U.S. DEPARTMENT OF THE INTERIOR
Bureau of Land Management
Safford District Office

Final Environmental Impact Statement Sanchez Copper Project

BLM-AZ-PT-93-001-3000

5.5	COMMENT LETTERS AND RESPONSES	5-10

Figure 3-3
CROSS-SECTION A - A'
AND B - B' - B'' - B'''

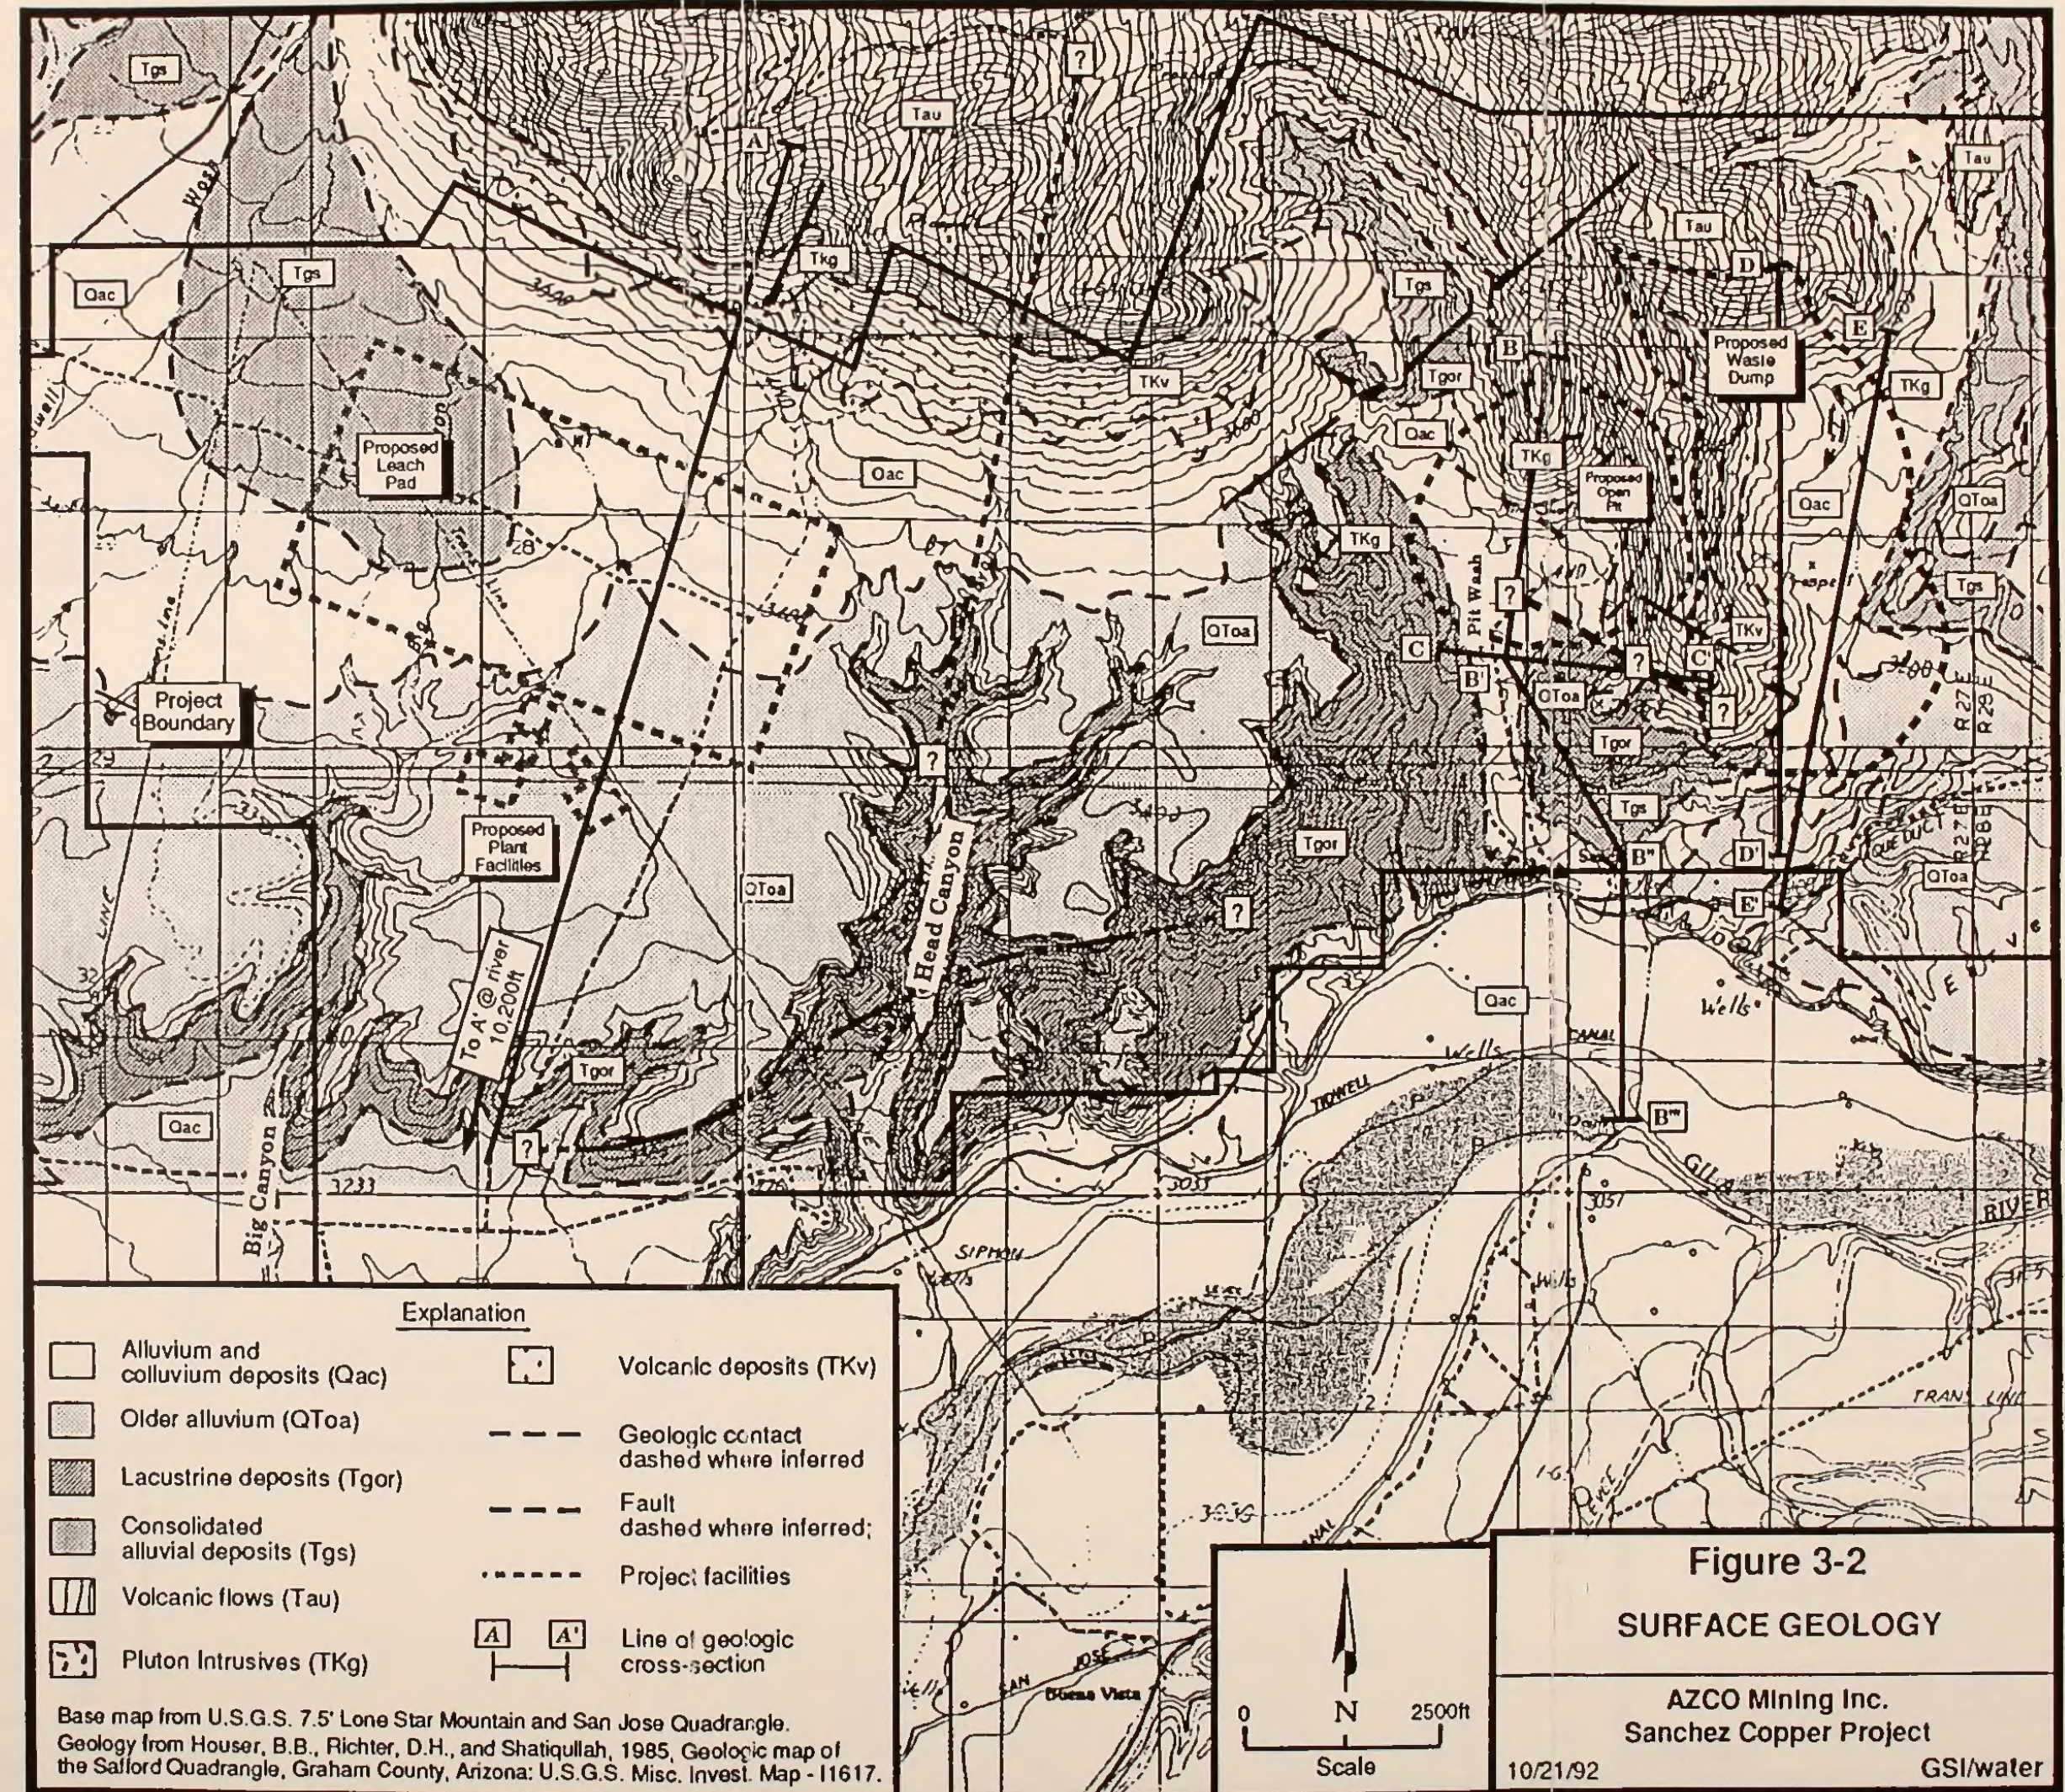
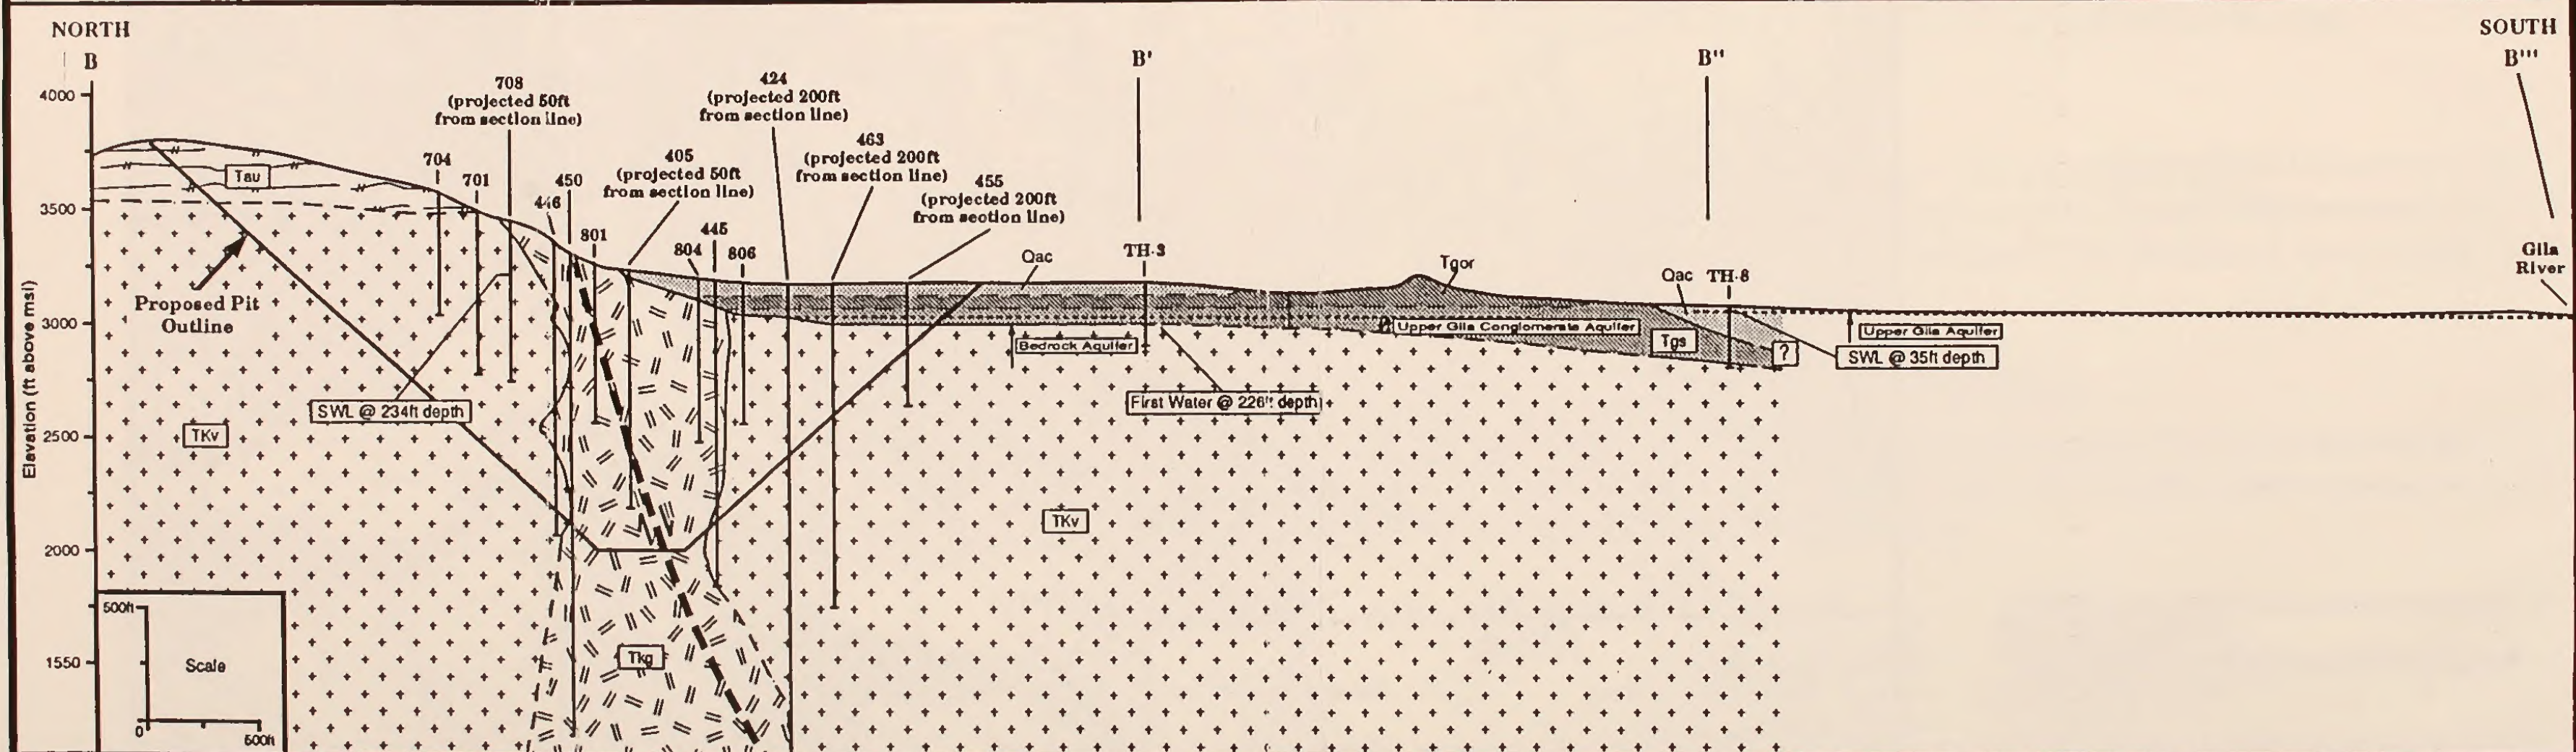
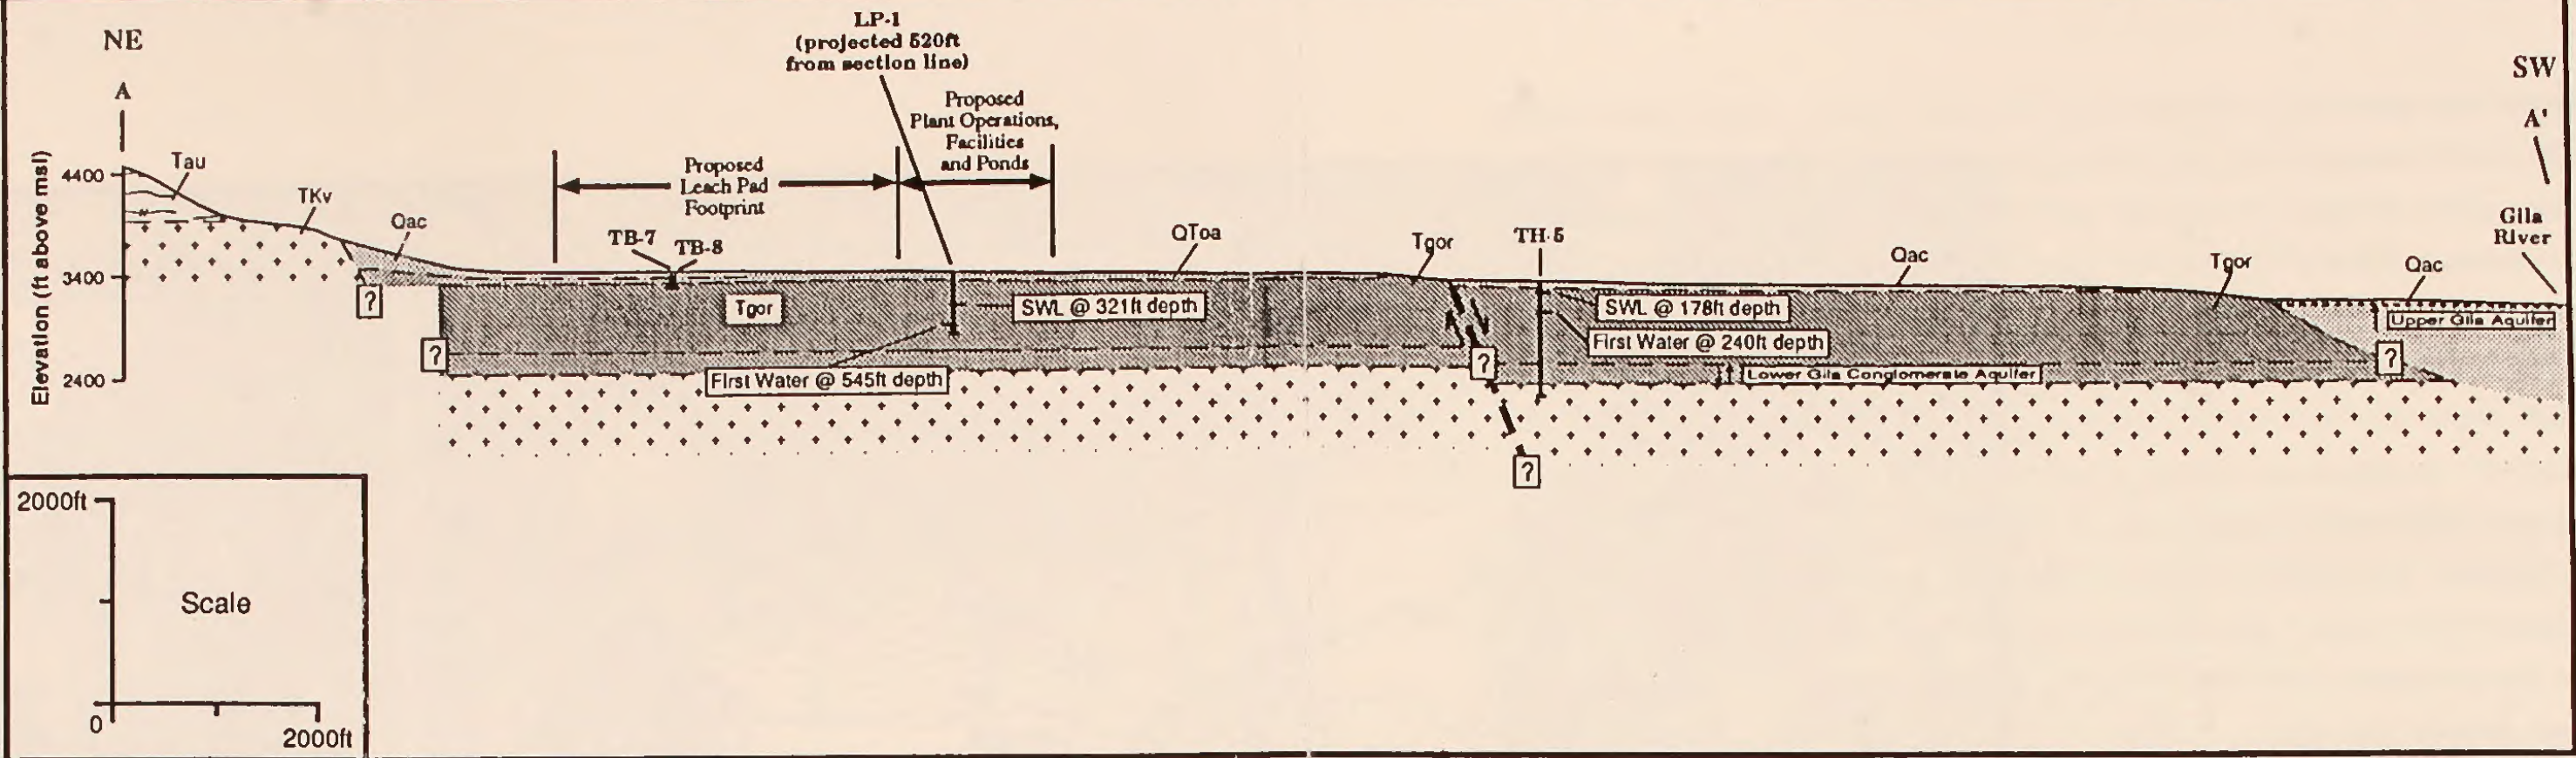
c. The North-South geologic cross-section in Figure 3-3 is inconsistent with that in Figure 3-4.

17-2 BLM requested that additional information be developed. This information was obtained by Mining & Environmental Consultants and is presented in Appendix C - Report on Waste Material Testing. The new Figure 3-3 presents new, site-specific, drill-hole data obtained in the pad area. Please also refer to revised Sections 3.2.1, 3.3, and 4.3.
